Docket Item # 15  
BAR CASE #2008-0192

BAR Meeting  
November 5, 2008

**ISSUE:** Amendment to Previously Approved Plans

**LOCATION:** 408 Duke Street

Figure 2: Original Arbor Design

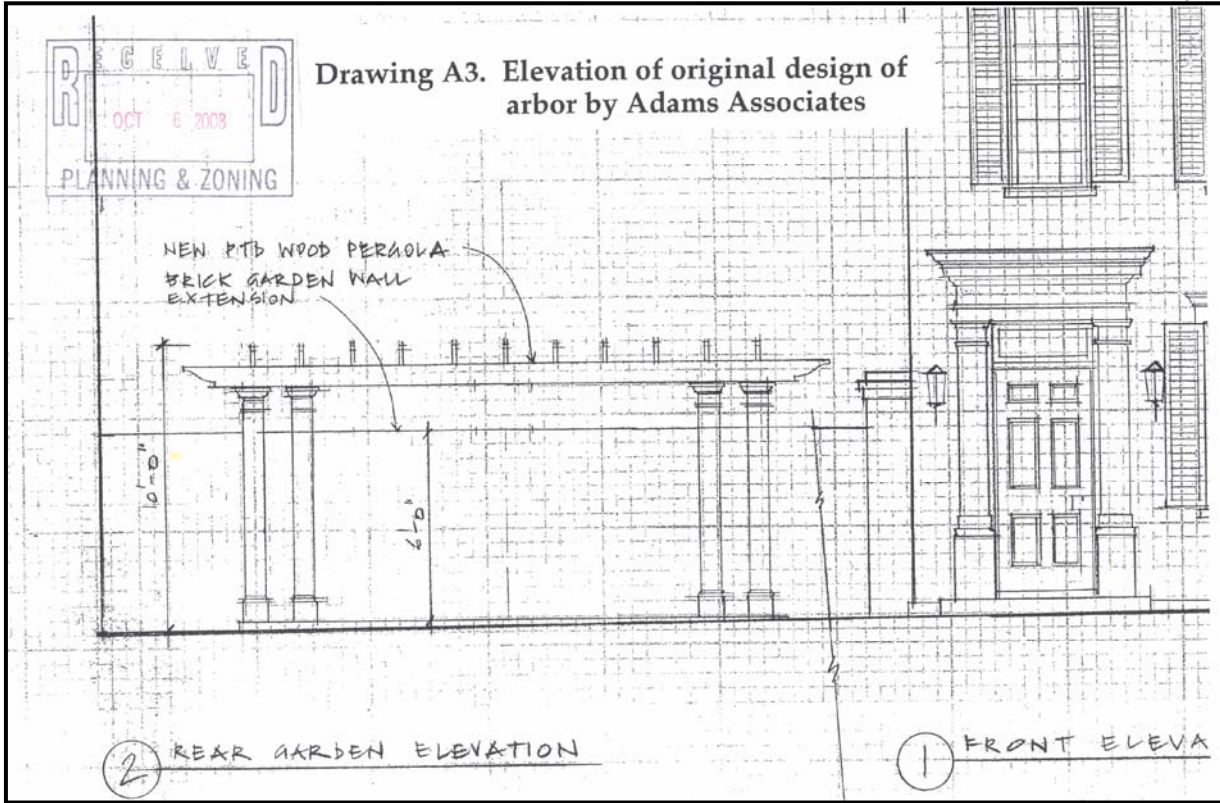
The applicant is requesting after-the-fact approval of a Certificate of Appropriateness for amendment to previously approved plans for the construction of an arbor at 408 Duke Street. An arbor structure had been approved by the Board in 2006, in a different location, at the southeast corner of the side yard. The original arbor was to be used as parking structure at the end of a driveway.

Figure 4: Arbor as constructed.

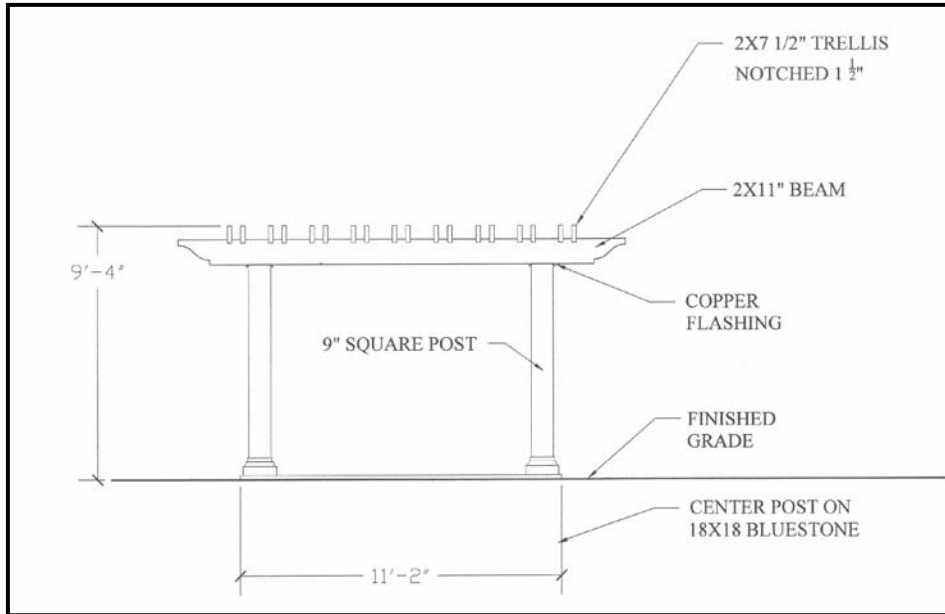
The current arbor is reduced in size from the prior proposed arbor. It is constructed of four columns, measuring 7'11" in height, with two beams resting on top of the columns. A series of beaver tail rafters rests on the posts, running east to west. The arbor is 11'2" in length, 9'4" in height at the top of the beams, and a depth of 5'6". The columns are squared with molding on the tops and bottom. The arbor is constructed of cedar painted white, with the post set in concrete footings. The floor of the arbor is a paving tile. A lattice screen feature is on the back side of the arbor. The original arbor was to be constructed in the southeast corner of the lot, to be approximately 18' in length, and 10'6" in width and 10' in height, with beaver tail rafters and wood Doric columns.

On the merits of the design and materiality of the arbor, Staff believes the arbor meets the requirements of the Ordinance and is appropriate and compatible to the historic house at 408 Duke Street. Furthermore, as constructed, the arbor really functions as a garden structure, rather than a parking structure, as was the traditional function of arbors and other garden elements. Also, the arbor is only minimally visible from Duke Street.

Figure 11: Site Plan showing actual location as constructed

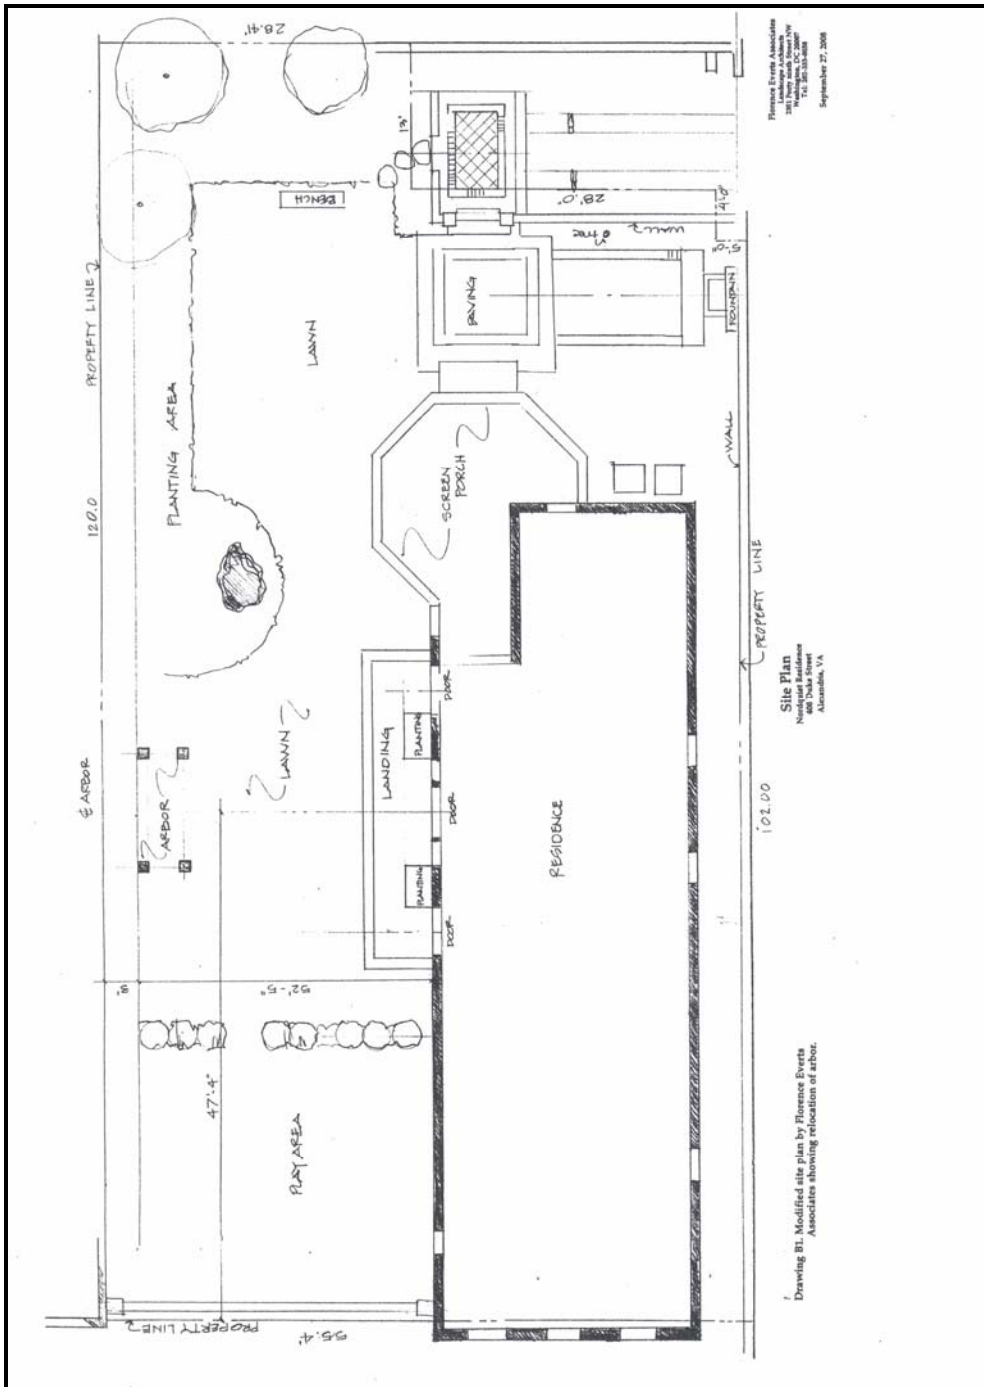
The arbor in its current location is on the eastern side of the side yard of 408 Duke Street, adjacent to an easement with 404 Duke Street. The columns of the arbor are 45 feet from Duke Street, and 3 feet from the neighboring property line, outside of the easement (this easement is a private property easement between the two property owners, not a City regulated easement). In this location, the arbor is in front of the kitchen window of 404 Duke Street. According to the applicant, the arbor was reduced in size and relocated in the course of the design of the landscaping master plan. The arbor was placed symmetrically in relation to the addition, directly across from the central French doors that open from the living room into the side garden. According to the applicant, the Planning & Zoning Department was contacted prior to construction to inform them of the change and whether any approvals were required. While P&Z was contacted, a BAR Staff member was not contacted. The P&Z Staffer indicated that an arbor with an open top such as this one did not require approval.

However, the issue of concern is the placement of the arbor in front of the kitchen window of 404 Duke Street. It is unfortunate that this is the location selected for the placement. While Staff support’s the design of the arbor, Staff would recommend that consideration should be given to relocating the arbor to a location that does not block the adjacent windows of 404 Duke Street.

**IV. STAFF RECOMMENDATION:** Staff recommends approval of the application with the consideration of relocating the arbor so as not to block the windows of 404 Duke Street.
